VIRGINIA ELECTRIC AND POWER COMPANY
RICHMOND, VIRGINIA 23261

VIRGINIA ELECTRIC AND POWER COMPANY
NORTH ANNA POWER STATION UNITS 1 AND 2
PROPOSED TECHNICAL SPECIFICATION CHANGES
REVISED CONTAINMENT ANALYSIS

Attachment 1
Discussion of Changes

Mark-up of Unit 1 and Unit 2 Technical Specifications Changes

Figure 4.1
Containment Air Partial Pressure versus Service Water Temperature
(Revised Tech Spec Figure 3.6-1)

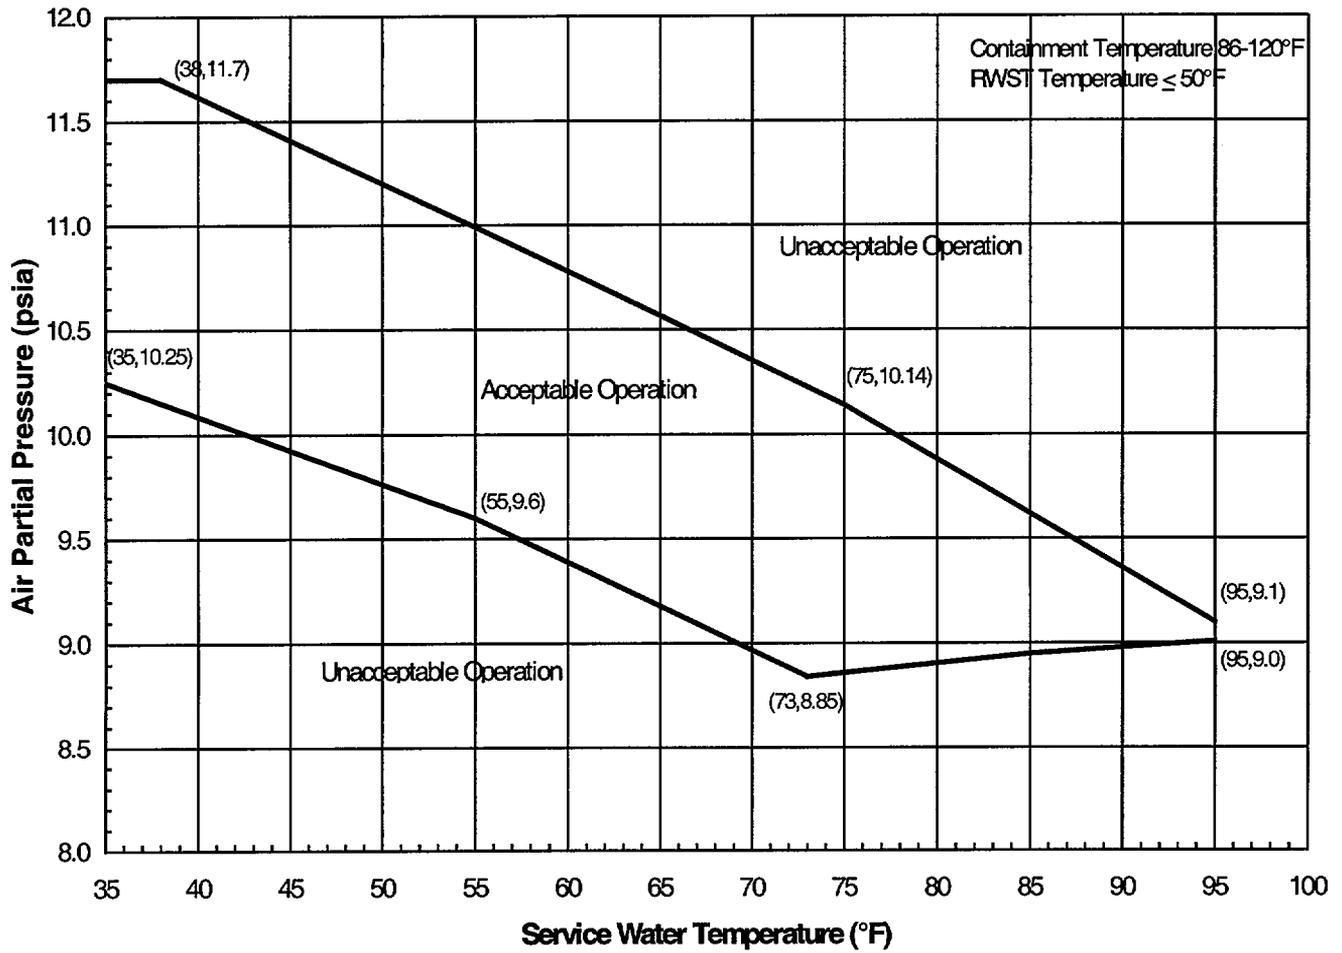
Technical Specifications Figure 3.6-1, "Containment Air Partial Pressure Versus Service Water Temperature" was revised as a result of the new containment analyses. The revised operating curve is provided as Figure 4.1. The peak pressure analysis sets the upper pressure limit below 38°F service water, the point where the peak pressure and depressurization analyses converge at 11.7 psia. The depressurization analyses create the upper pressure limit between 38°F and 95°F service water. The lower bound of the Technical Specifications containment air partial pressure operating curve is defined by the LHSI pump NPSH results for service water temperature greater than 73°F and by the RS pumps NPSH results for service water temperature less than 73°F. The containment air partial pressure is 8.85 psia for 73°F service water, where the curves intersect. This represents the minimum operating containment air partial pressure on Figure 4.1.

Figure 3.6-1: Containment Air Partial Pressure versus Service Water Temperature

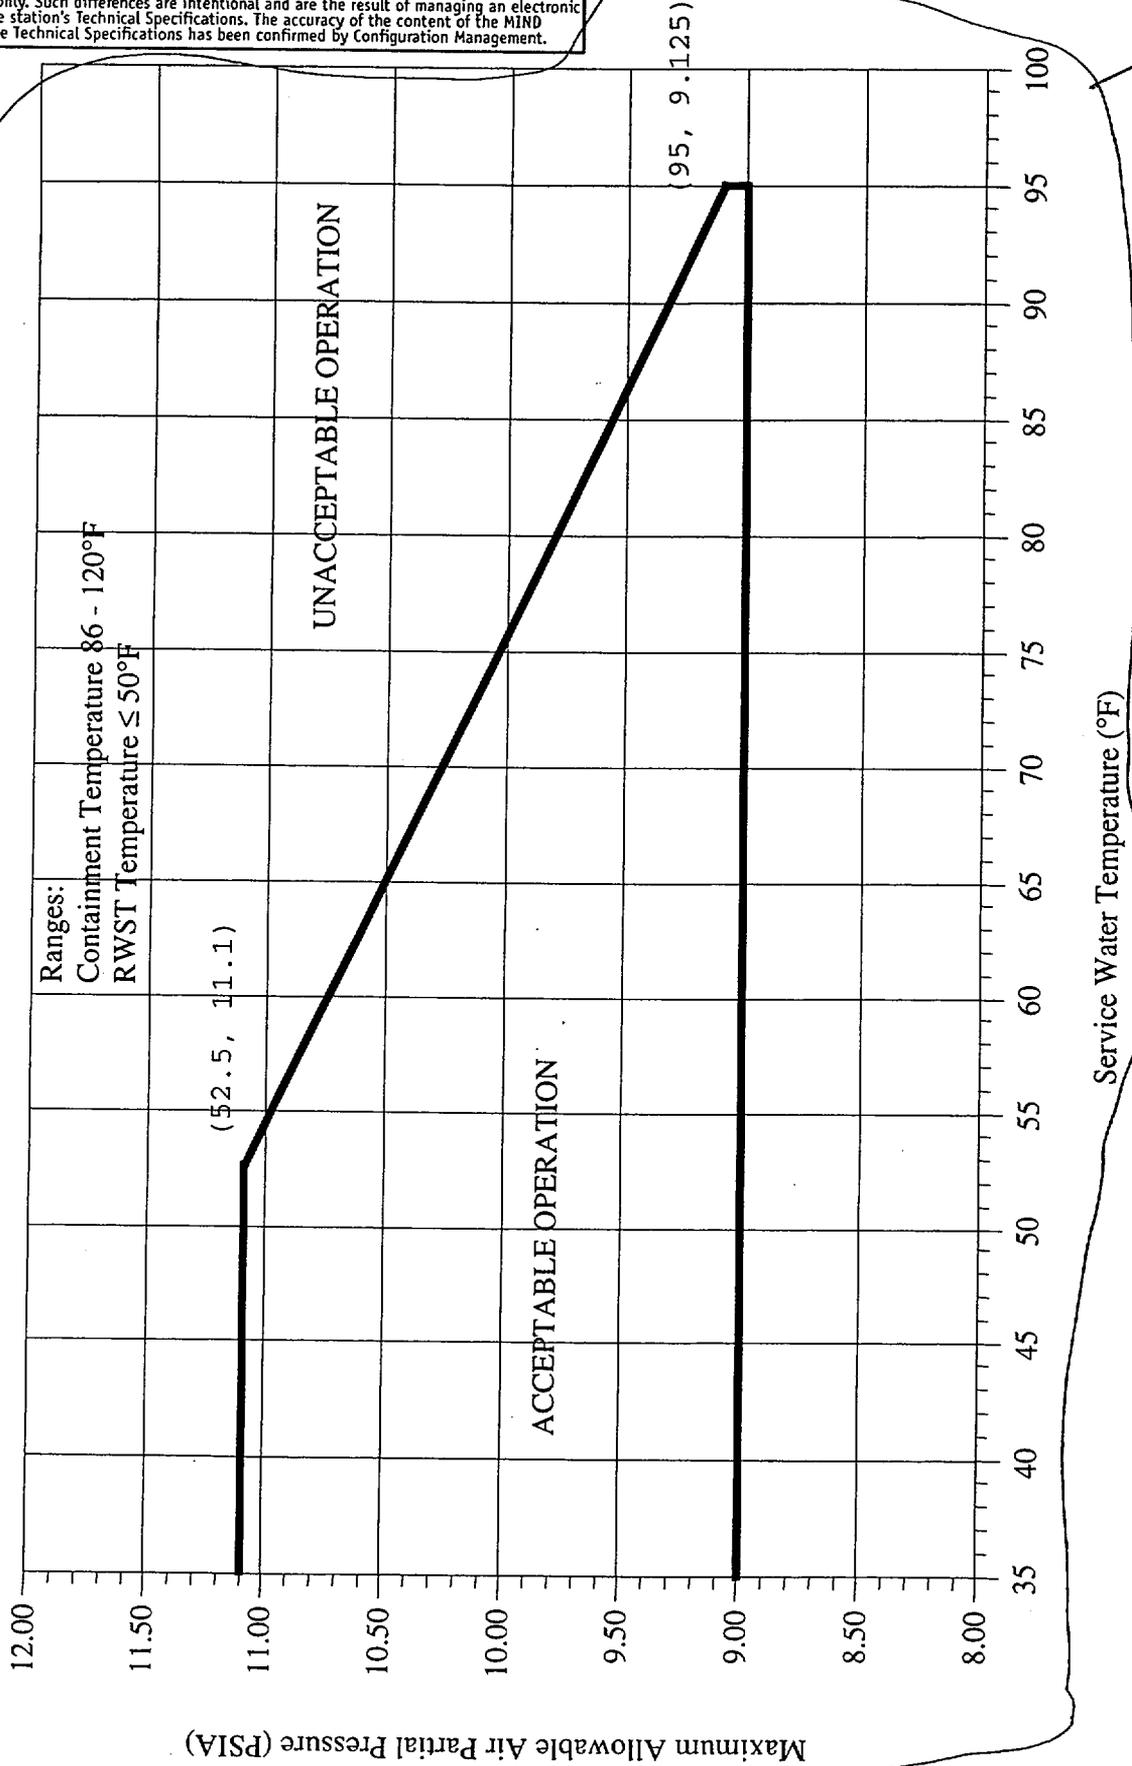
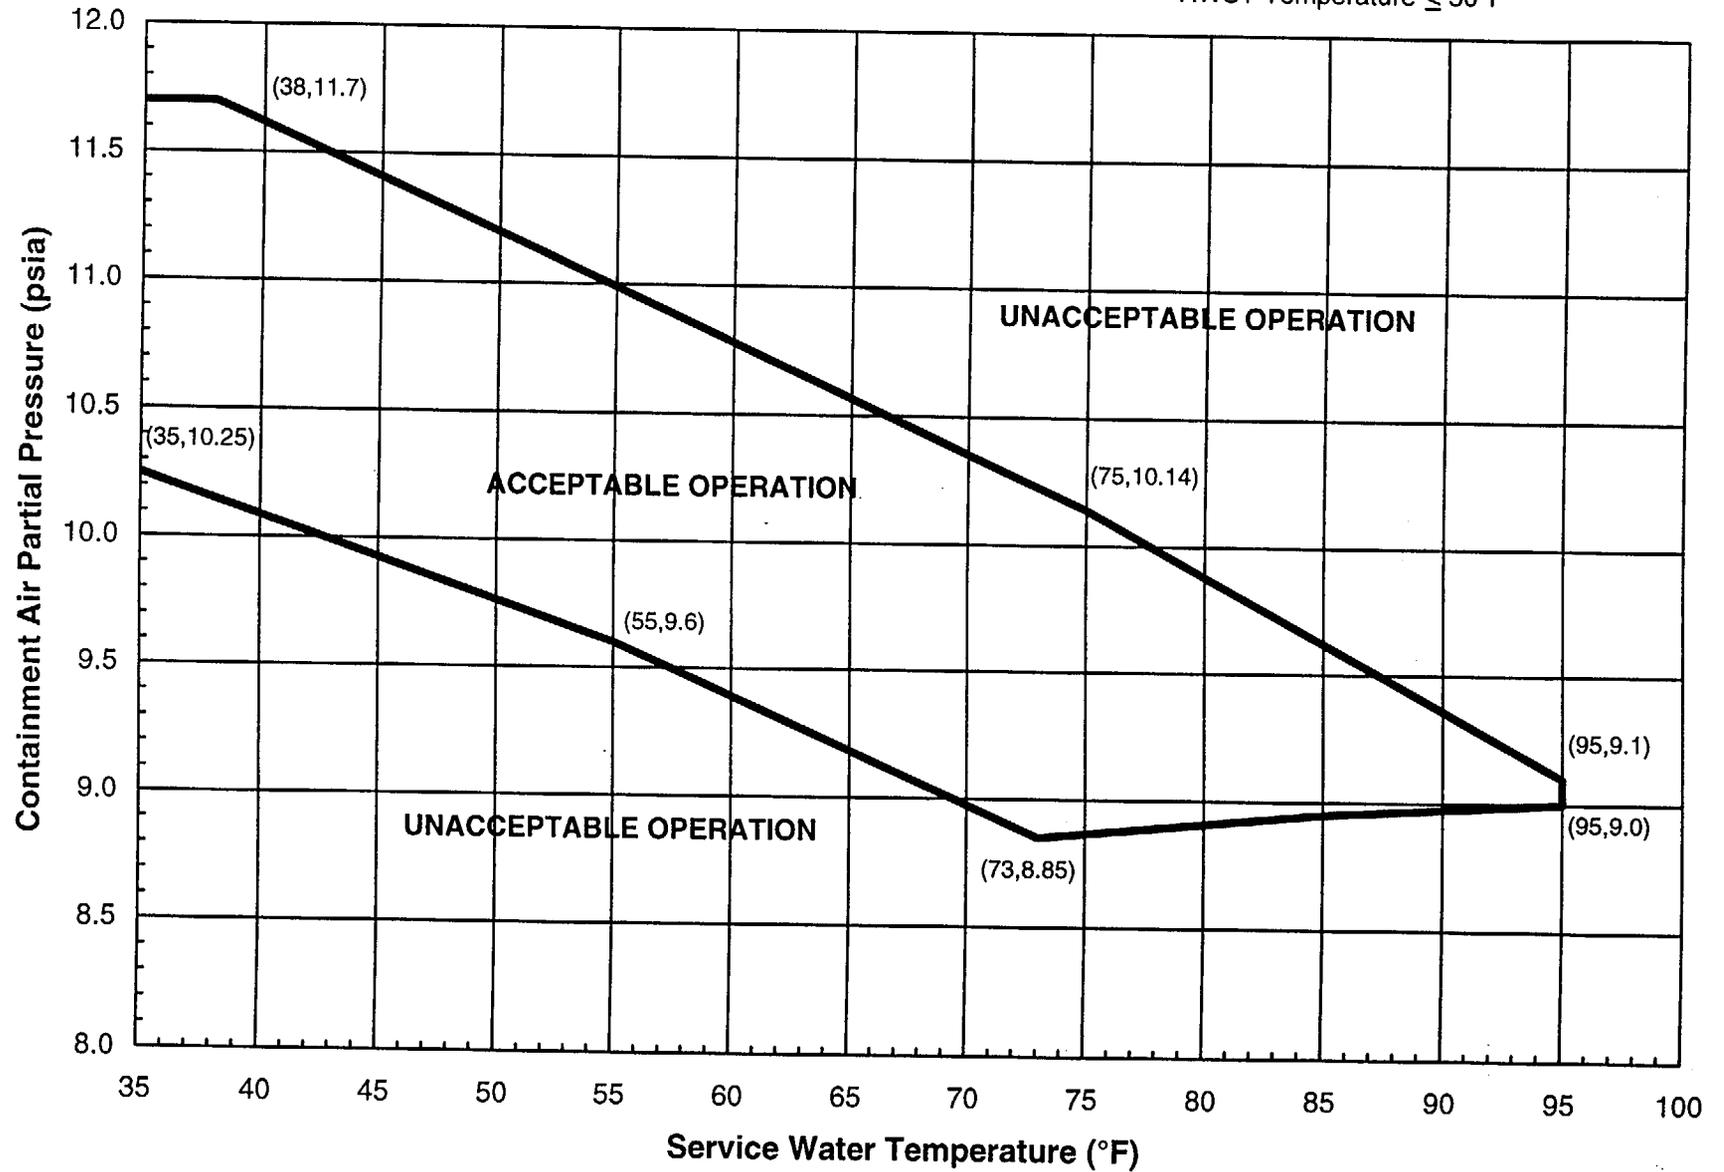
With the containment internal air partial pressure *outside the acceptable operation region* < 9.0 psia or above the applicable limit shown on Figure 3.6-1, restore the internal air partial pressure to within the limits within 1 hour or be in at least HOT STANDBY within the next 6 hours and in COLD SHUTDOWN within the following 30 hours.

Replace with revise Figure 3.6-1

Ranges:
Containment Temperature 86-120°F
RWST Temperature $\leq 50^\circ\text{F}$

Figure 3.6-1: Containment Air Partial Pressure versus Service Water Temperature

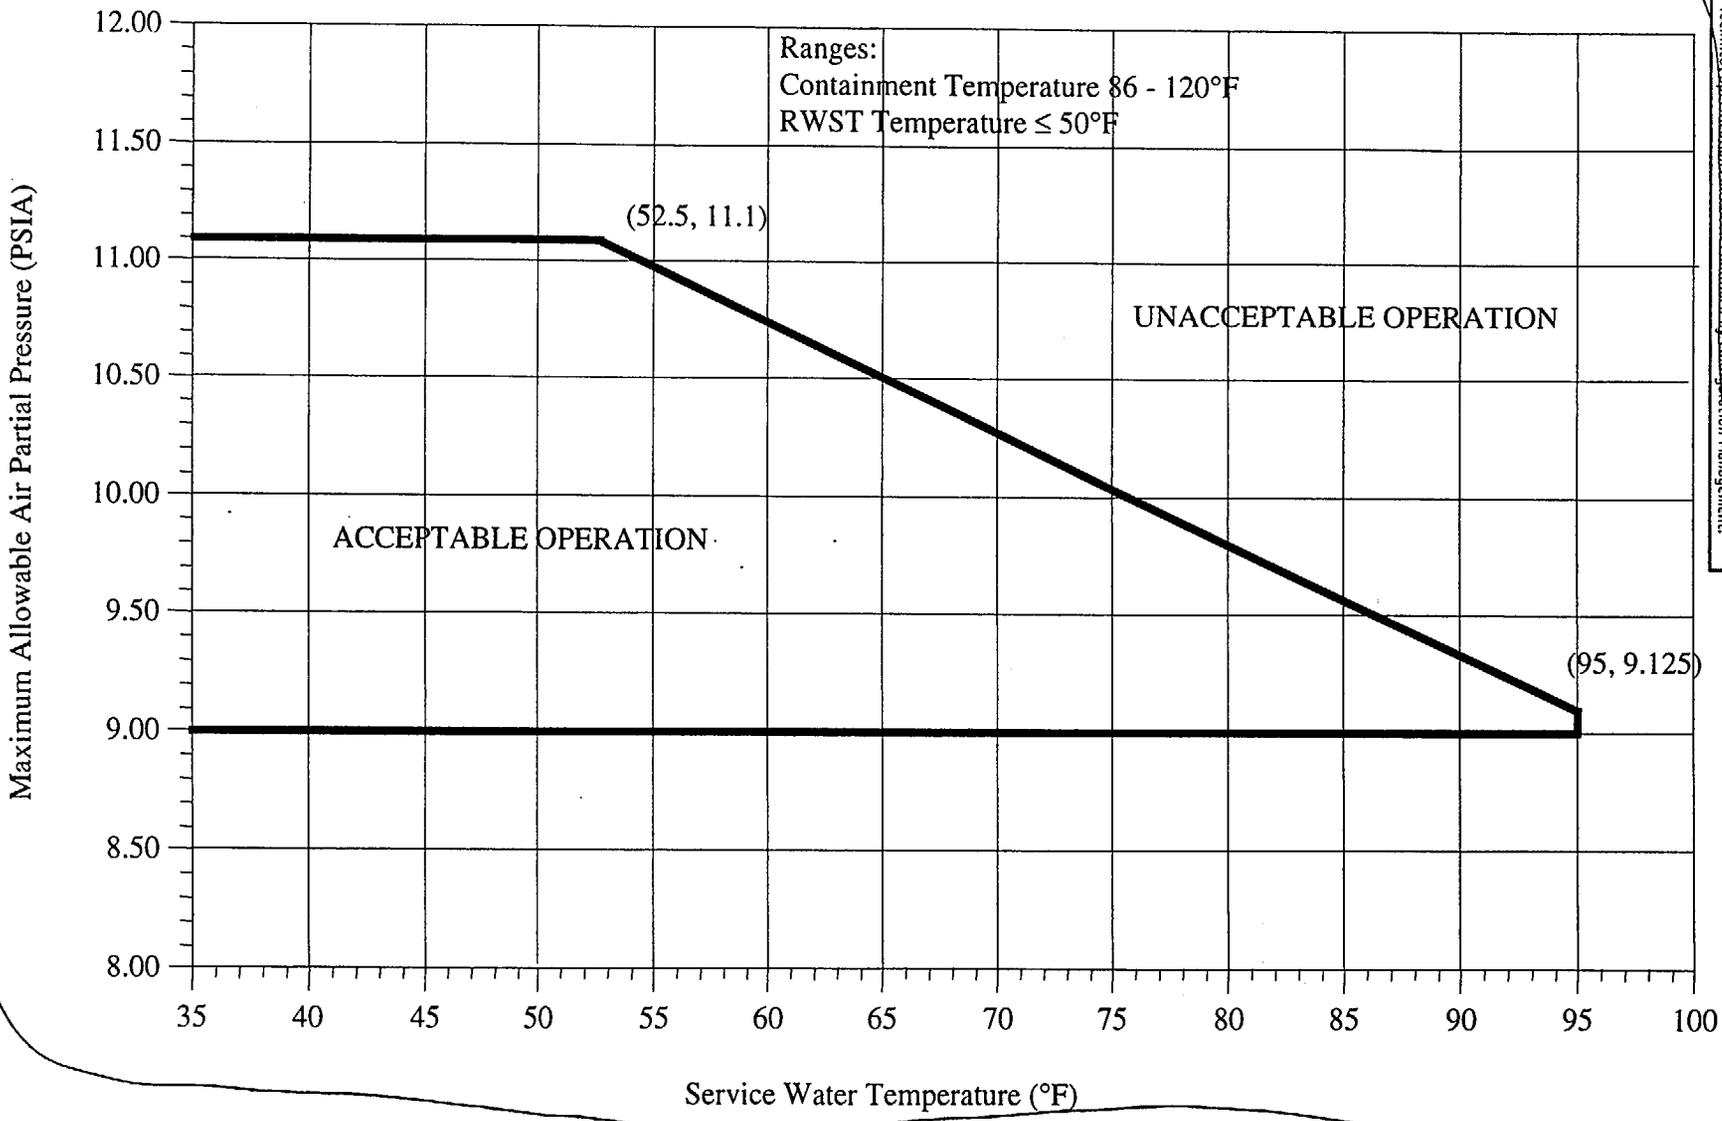
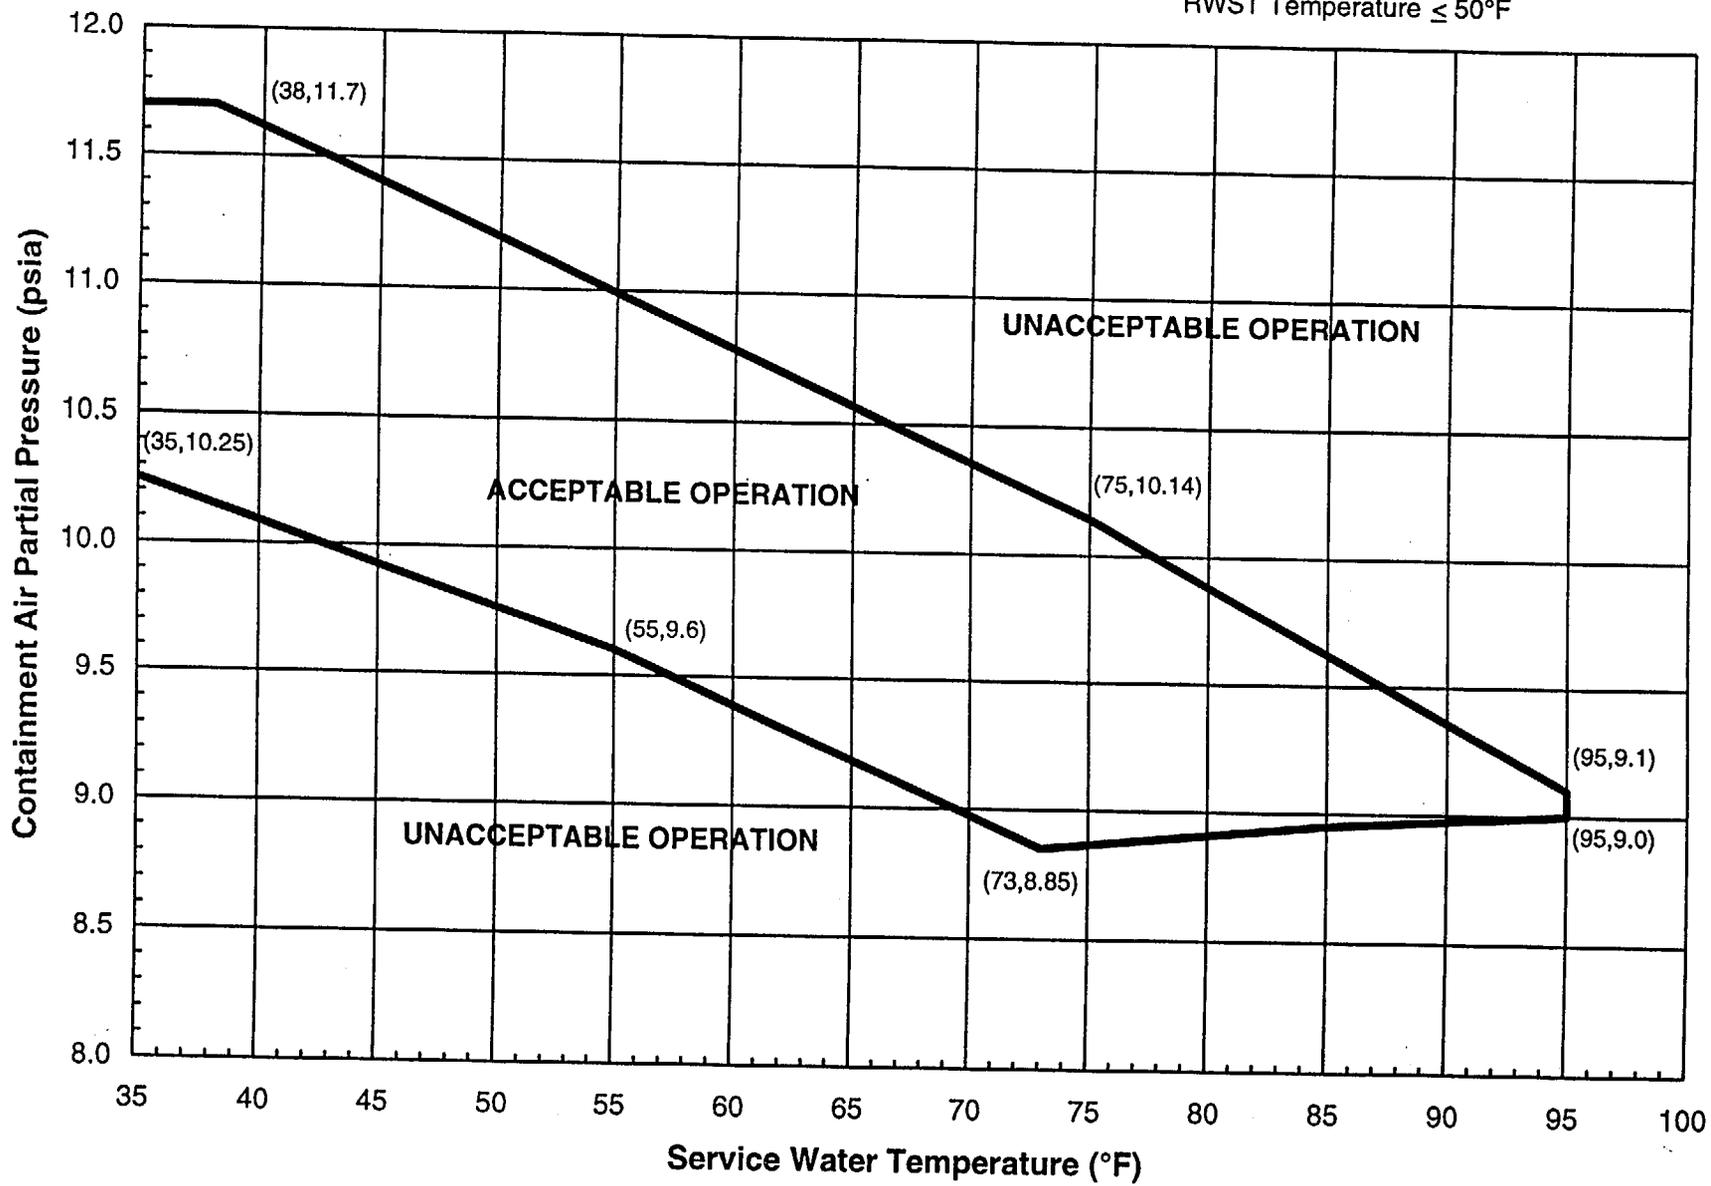
outside the acceptable operation region

*Replace w
new figure
3.6-1*

Ranges:
Containment Temperature 86-120°F
RWST Temperature $\leq 50^\circ\text{F}$
